SUBJECT: Responds to 780821 NRC ltr requesting addl info re spent  
 fuel mod. Forwards "Boraflex 1 Suitability Rept." *526 RPT*

Re: Nine Mile Point Unit #1  
Docket No. 50-220  
DPR-63

Response to August 21, 1978

NUCLEAR REGULATORY COMMISSION QUESTIONS

FIGURE 1

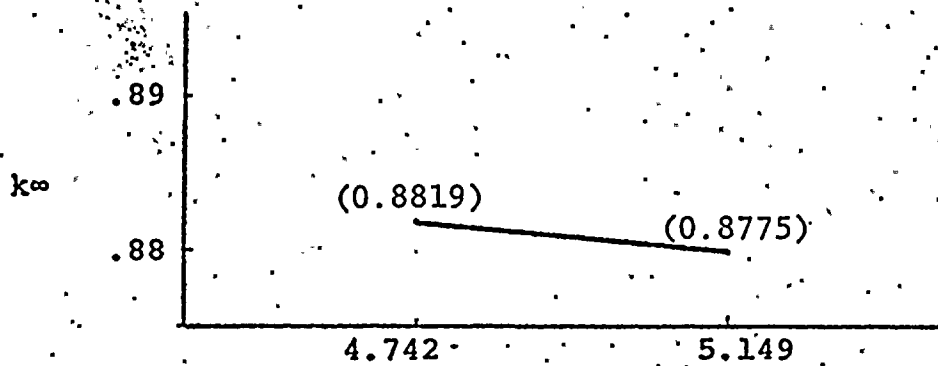
Provide the calculated change in the storage lattice  $k^\infty$  with a small change in the boron-10 concentration in the Boraflex plates.

The calculated change in the storage lattice  $k^\infty$  with a small change in boron-10 concentration in the Boraflex is shown in Figure 1.

The Boraflex will be exposed to pool water, however, the silicone rubber matrix of the Boraflex essentially coats the  $B_4C$  and  $B_2O_3$  particles to prevent the water from contacting it. A 4700 hour test at 240 F in Borated water has shown no leaching to occur. Even if leaching should occur, analysis shows this small decrease in Boron content would have little effect on the rack  $k_{\infty}$  (see figure 1).
